**Reactor Oversight Process Task Force FAQ Log – July 15, 2015**

**Dated August 12, 2015**

**NEI 99-02 FAQ 15-02**  
**Prairie Island Power Change December 2014**

**NEI 99-02 FAQ 15-03**  
**Unavailability Monitoring of Low-Risk Trains**

Figure 1 -- Unit 1 RCS Unidentified Leakage during from 12/03/14 through 12/10/14. Each data point was captured while performing SP 1001AA, Daily Reactor Coolant System Leakage Test. The off-normal condition was first discovered on 11/30/14 (AR 1457811) and the ODMI was signed on 12/9/14.

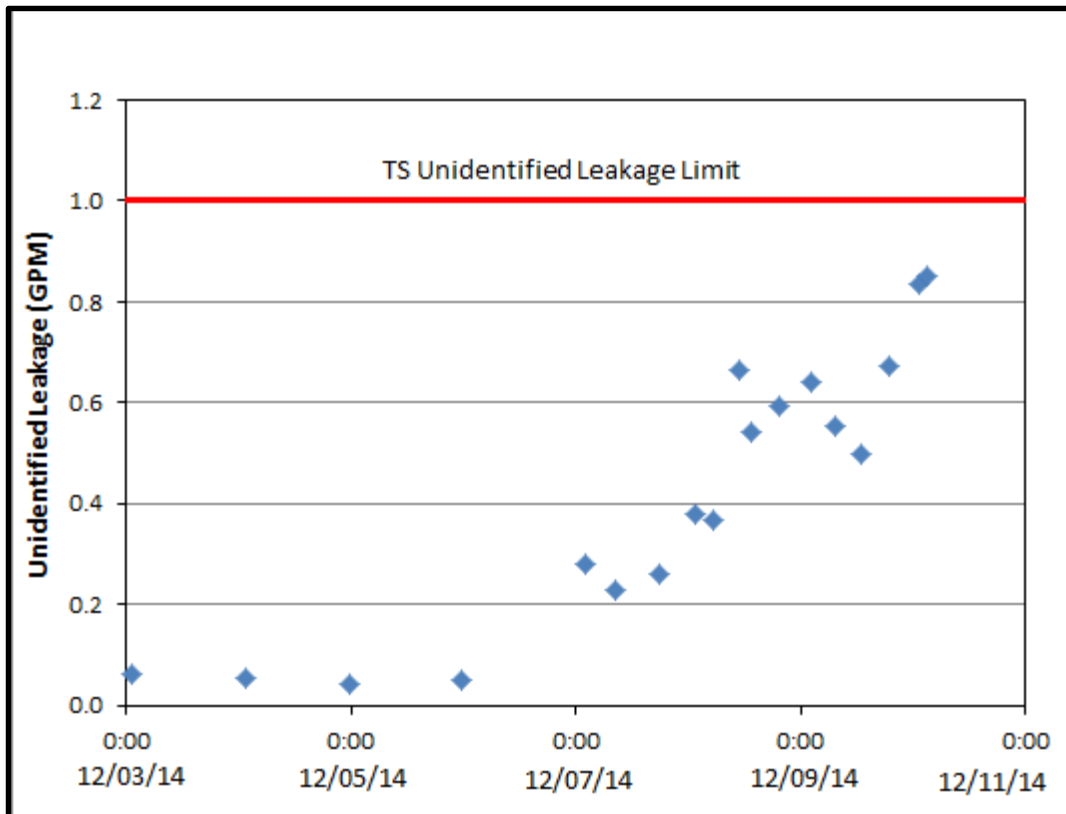
On December 10, 2014, PINGP Unit 1 commenced a power reduction and initiated a forced outage in response to leakage through the 12 Reactor Coolant Pump (RCP) seal. See the timeline below for a description of the actions taken surrounding this event. Figure 1 shows the unidentified leakage rate during the time period of interest.

The NRC Resident agrees with the description of the event. However, it is not clear from NEI 99-02 when the off-normal condition was first discovered and whether the licensee adequately prepared plans to reduce power.

The point of disagreement between the licensee and NRC inspector is on what constitutes “discovery”.

This situation did not degrade beyond predefined limits or require rapid response. Throughout the event, the maximum allowable unidentified leakage of 1.0 GPM, as defined in PINGP's Technical Specifications, was not exceeded. The decision to reduce power, aided by guidance in ODMI 1457811, was conservative in nature and provided for a safe transition of the unit to Mode 5. Since normal operating procedures were used to reduce power in Unit 1, a rapid response designated by use of abnormal operating procedure 1C1.4 AOP1, Rapid Power Reduction Unit 1, did not take place.

NEI 99-02 states that "the key element to be used in determining whether a power change should be counted as part of this indicator is the 72-hour period and not the extent of planning that is performed between the discovery of the condition and initiation of the power change." The initiation of AR 1457811 on 11/20/2015 identified the apparent degradation to the reactor coolant pump seal and constitutes "discovery" for the purposes of this indicator. The plant shutdown occurred on 12/10/2015, well in excess of the 72-hour period required prior to the power reduction. Therefore, the power reduction commenced on 12/10/2014 does not count as an Unplanned Power Change per NEI 99-02.
